Proj. No.:  
File Loc.: Golden, Colorado

**RE: RESPONSE TO NDEQ EXCURSION MONITORING ISSUES**

This letter report provides a response to Nebraska Department of Environmental Quality concerns regarding excursion monitoring at the Crow Butte Resources (CBR) uranium ISR facility.

**Figure 1. Water Balance in WH45/47 and Chloride Concentration in CM9-3  
October 2007 Through June 2008**

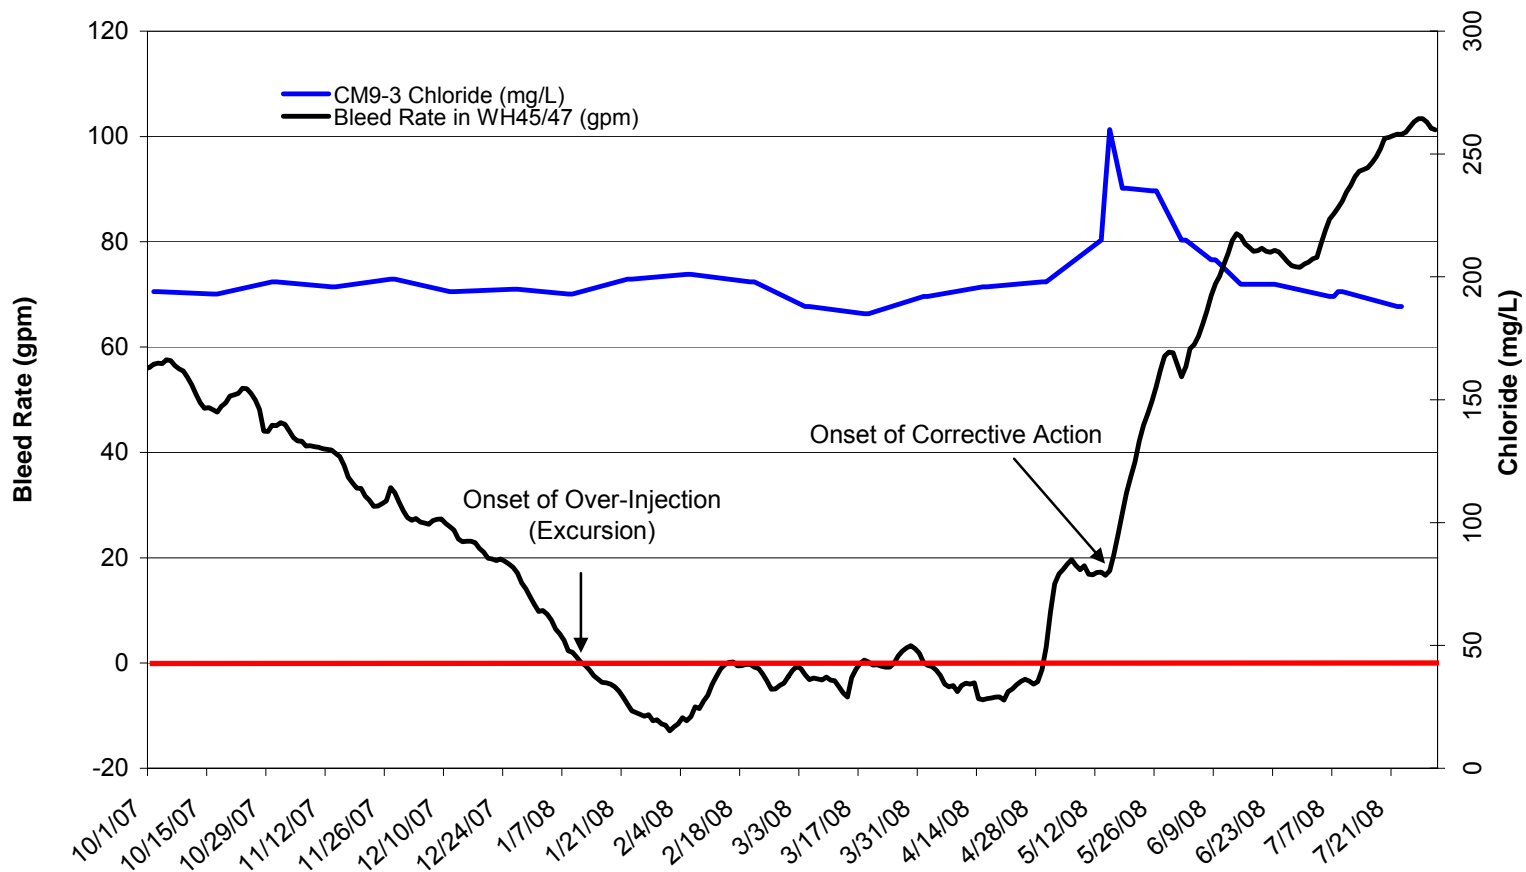
***Issue 1 - When Upper Control Limits (UCL's) are exceeded in a monitoring well, how far beyond the monitoring well do the constituents travel before the corrective action captures them?***

In the case of the May 2008 excursion in MU9, water balance data collected from Well Houses 45 and 47 (WH45/47) indicates that a local over-injection of mining solutions began in the first week of January 2008 and continued sporadically through the end of April 2008 (Figure 1). The average rate of over-injection in WH45/47 during this period was approximately 12 gallons per minute (gpm). The onset of the excursion was reflected as a rise in water level in the adjacent monitoring well ring during this time, including excursion monitoring wells CM9-3 and CM9-5 (Figures 2 through 10).

In this calculation, it is assumed a starting date for the excursion of January 1, 2008 corresponds to the onset of a local over-injection in WH45/47. For CM9-3, an excursion arrival date of May 15, 2008 is assumed based on the first noticeable increase in chloride, alkalinity and conductivity at this location (Figure 1). The resulting time of travel for conservative chemical parameters is 135 days. Given a distance of 270 feet from the mine patterns to monitoring well CM9-3, the groundwater velocity and speed of conservative chemical movement during the excursion is estimated to be 2.0 ft/day. A similar analysis for well CM9-5 using a distance of 250 feet from the mine patterns to the monitoring well yields a groundwater velocity of 1.85 ft/day. The resulting groundwater velocities calculated for CM9-3 and CM9-5 are very similar.

In response to the May 2008 excursion event, CBR began excursion corrective action by curtailing injection and increasing the extraction rate from perimeter production mining wells in WH45/47. Excursion corrective action was initiated immediately on May 15, 2008 as shown in Figure 1.

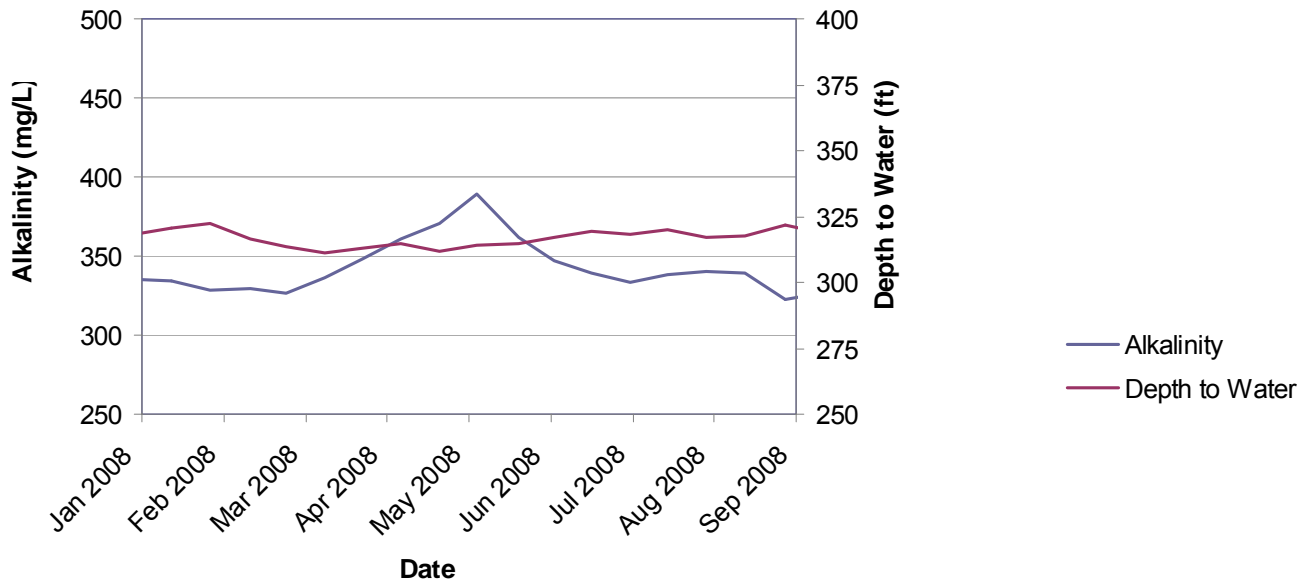
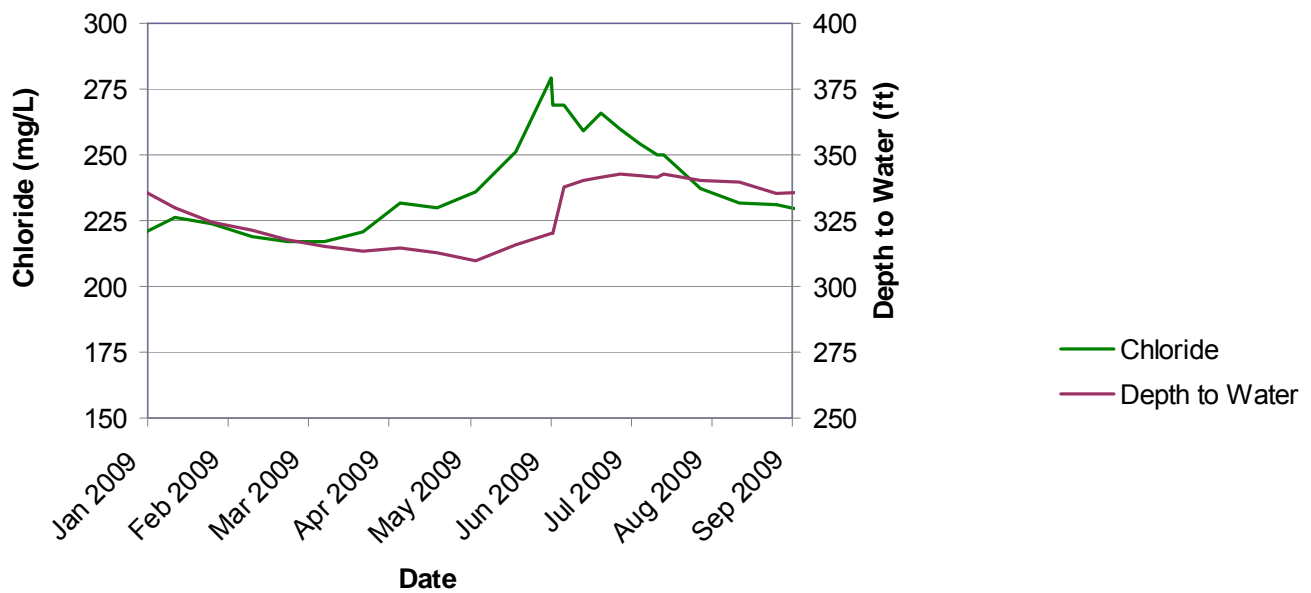
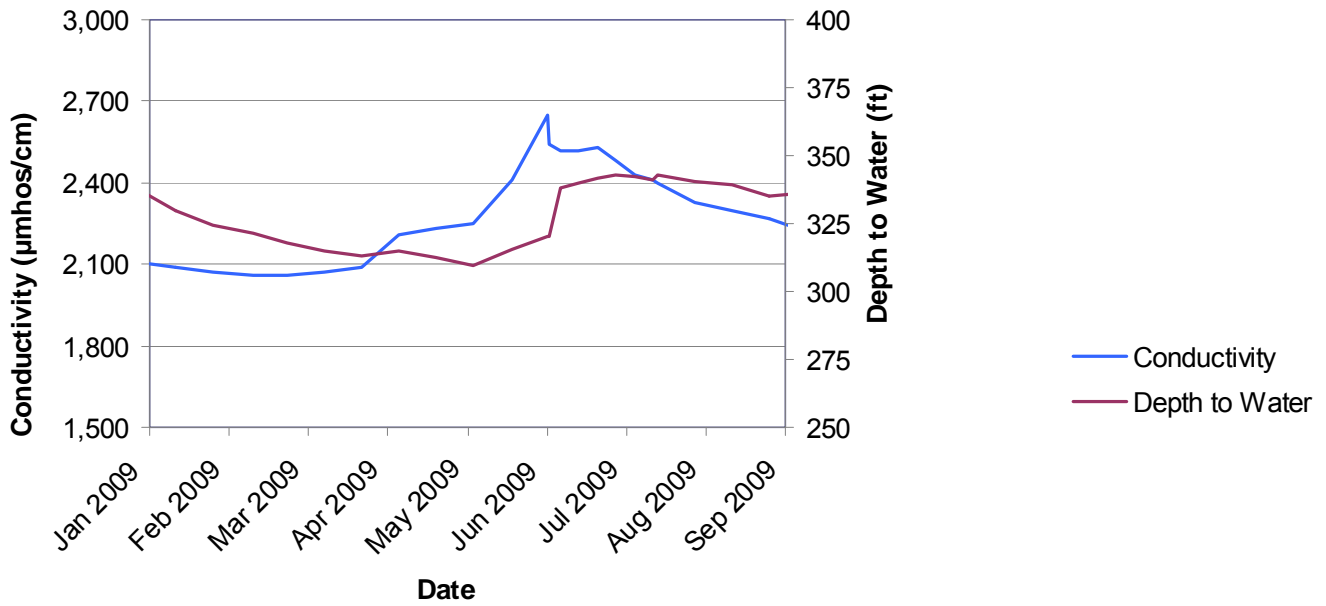
**Issue 2: *Could production fluids from the excursion detected in Mine Unit 9 in May 2008 and June 2009 increase uranium concentrations?***

Excursions were detected at wells CM9-3 and CM9-5 in May 2008 and during a separate excursion at well CM9-4 in June 2009. Indicator parameter data for these monitoring wells are provided in Tables 1 through 3 along with available uranium concentrations and pH data. The data demonstrate that the excursions were resolved quickly, with the indicator parameter concentrations returned to less than the lower control limits shortly after the excursions began. Uranium concentrations measured in samples from wells CM9-3 and CM9-5 after the May 2008 excursion (e.g. August 2008 and September 2008) remained consistent with pre-excursion concentrations and are significantly below the uranium groundwater restoration standard (Tables 1 and 3).

If a constituent does not associate with the solid phase through precipitation or sorption, its  $K_d$  is 0 ml/g and the constituent moves at the same speed of groundwater ( $R_d = 1$ ). Because chloride solid phases are extremely soluble and chloride is negligibly sorbed by aquifer solids, chloride has a  $K_d$  equal to 0 ml/g and an  $R_d = 1$  for groundwater transport at the CBR site. Consequently, chloride is among the first constituents to arrive at a monitoring well during an excursion. Because alkalinity is mainly composed of carbonate ions that would be poorly attenuated at the site and conductivity depends on the total dissolved ions in solution, these parameters also behave conservatively and in a manner similar to chloride. This effect can be seen in the monitored alkalinity, chloride and conductivity data for wells CM9-3, CM9-4 and CM9-5 (Figures 2 through 10), which show that these three parameters simultaneously increased during the excursions.
